LOCATION: Fisher Road, at the terminus of Patrick Drive

REQUEST: An application to replat a 1.349-acre tract of land containing all of Lots 1 through 3, and a tract of land in City Block 2962 to create 6 residential lots ranging in size from 7,515 square feet to 11,536 square feet and to remove an existing 30-foot platted building line along the north line of Fisher Road on property located on Fisher Road, at the terminus of Patrick Drive.

Case no: **S212-183R**

EXISTING AREA ANALYSIS MAP

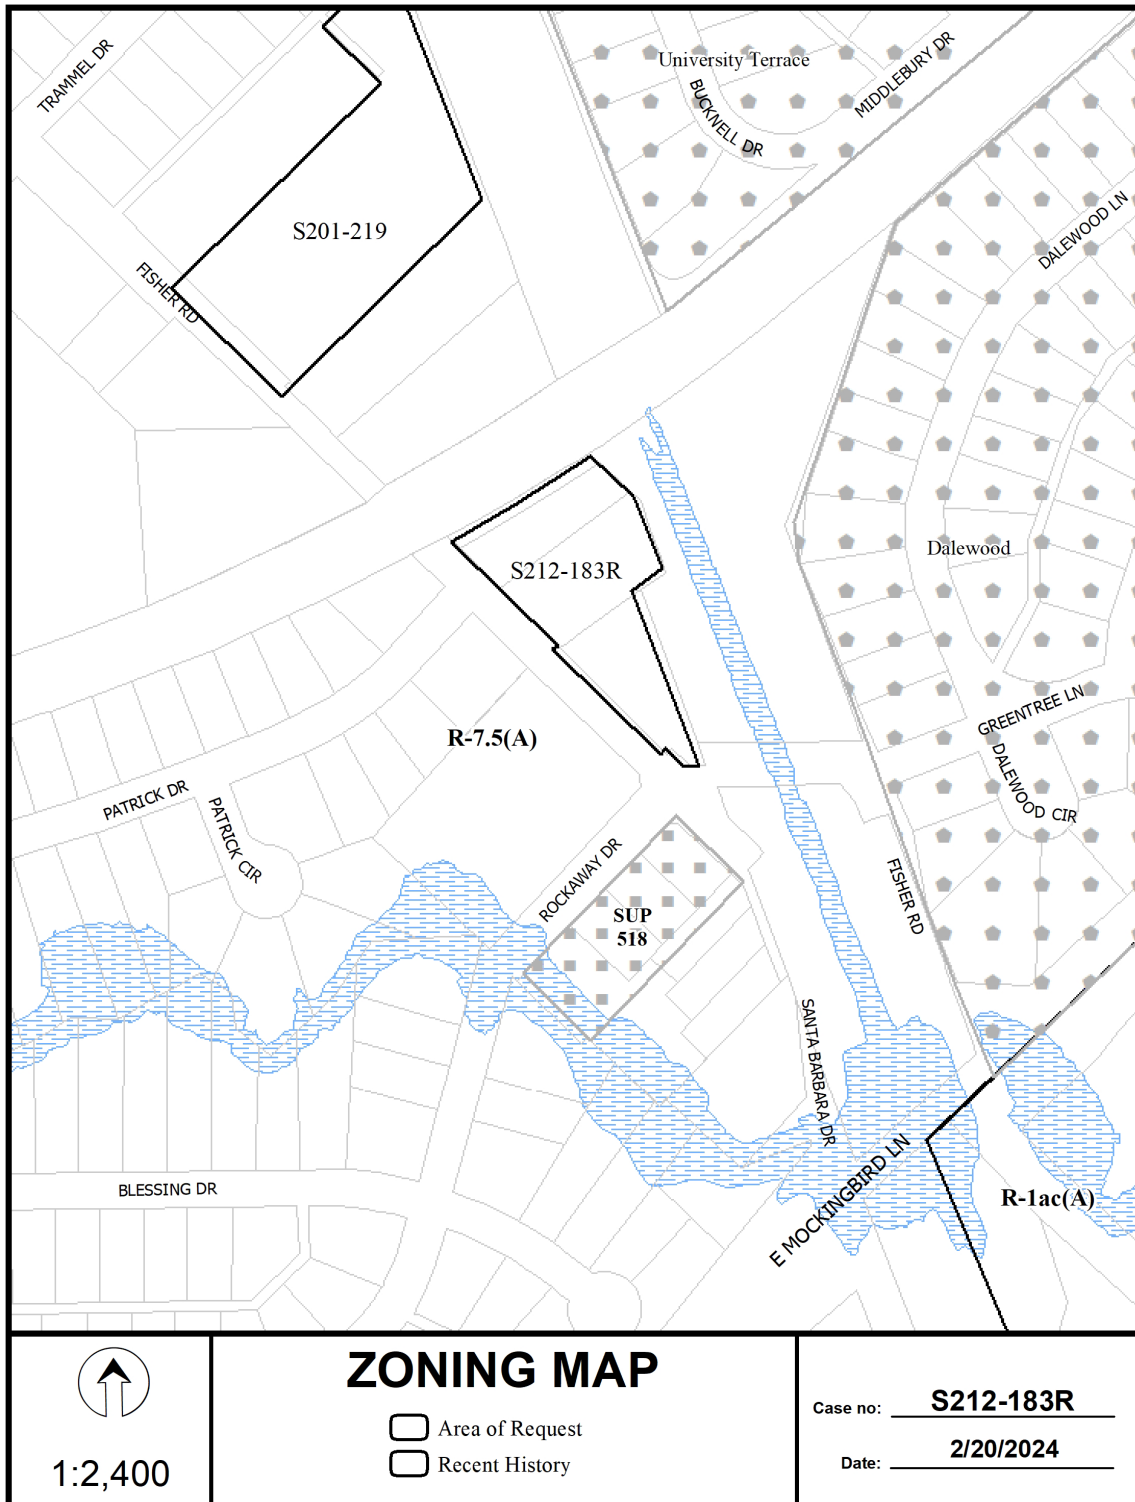
Staff finds that there is no established lot pattern within the immediate vicinity of the area (*refer existing area analysis map*); and the request is in compliance with Section 51A-8.503 and also with the requirements of the R-7.5(A) Single Family District; therefore, staff recommends approval subject to compliance with the following conditions.
